SUNDRY NOTICES AND REPORTS ON WELLS

**Eaves A #8
Southwest Royalties, Inc.
API No. 30-025-12012
Conditions of Approval**

**Eaves A #8
Yates 7 Rivers
Lea, NM**

WELLBORE DIAGRAM

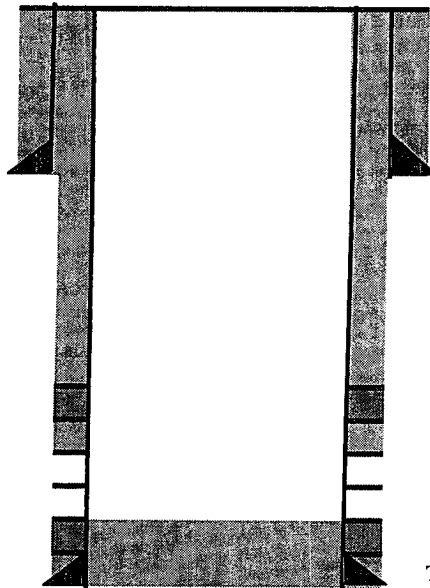
- 1. CIBP can be capped with 35' of cement if bailed, otherwise 25 sacks is okay. Tag plug.**
- 2. Plug required at 7-5/8" shoe with a minimum of 50' below and 50' above. Plug should be a minimum of 25 sacks and for the depth of 1109', an additional 10% is to be added to the slurry as per Onshore Order #2. Tag plug.**
- 3. Spot 25 sack plug at surface.**
